MEMORANDUM

To: Pam Skaggs
Through: Bob Sutter 
From: Shane Bendixsen 
Subject: Water Right Transfer 5389

GROUND WATER ELEVATIONS

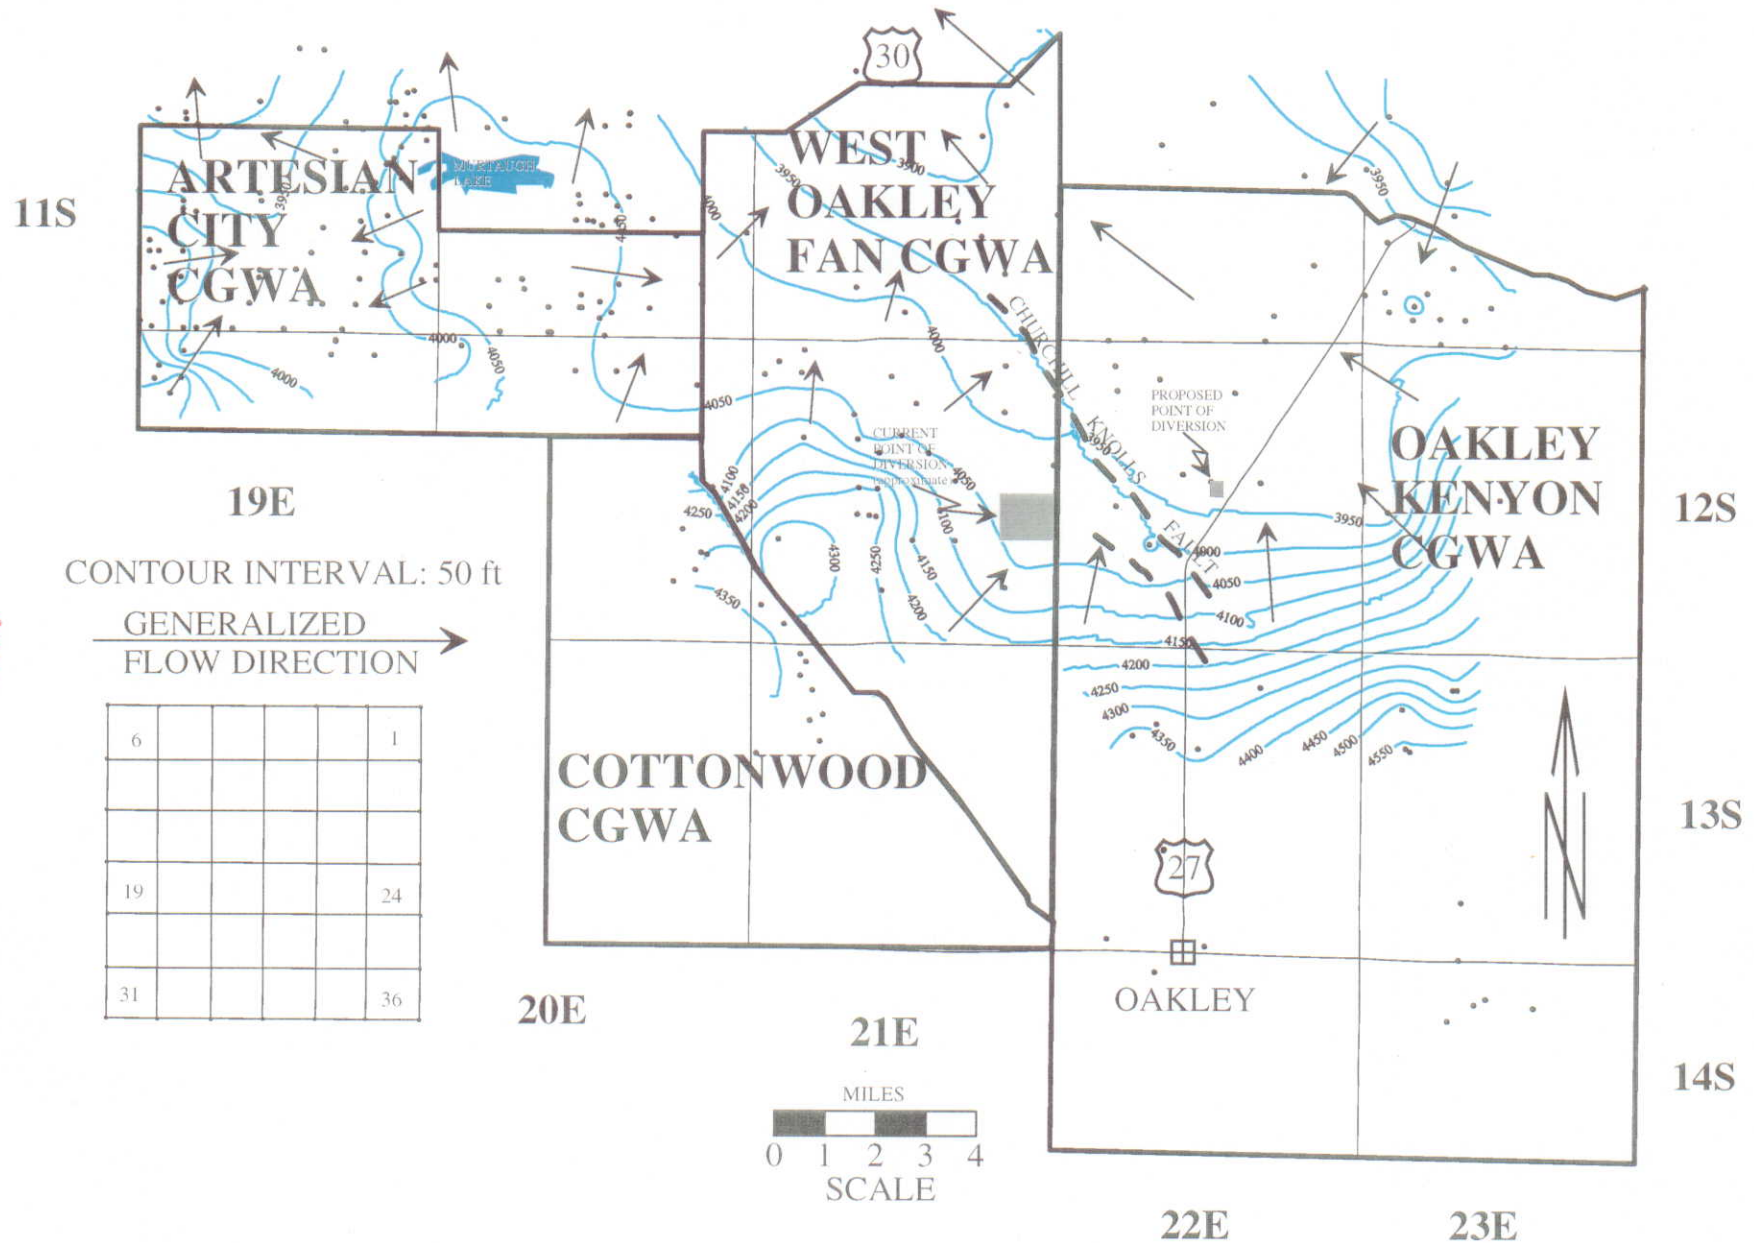
Attachment #2 presents ground water elevations and flow directions based on 230 wells measured in April and March, 1984. This is the only mass ground water level measurement for the area. As presented, the faults do influence ground water flow directions and elevations and the hydraulic connection between the multiple aquifers is not completely understood. Therefore the "exact" elevations and flow directions are somewhat open to interpretation and can vary as to how one interprets the data, but the generalized flow directions remain the same.

Flow at the current point of diversion is northeast and at some point downgradient slowly turns to the north and then to the northwest. Ground water flow at the proposed point of diversion is approximately north and then downgradient turns northwest. Flow at both the current and proposed points of diversion exit the area at the same point. Flow then is northwest under the Snake River into the Eastern Snake River Plain Aquifer. In this area the Snake River is considered perched and not hydraulically connected to ground water.
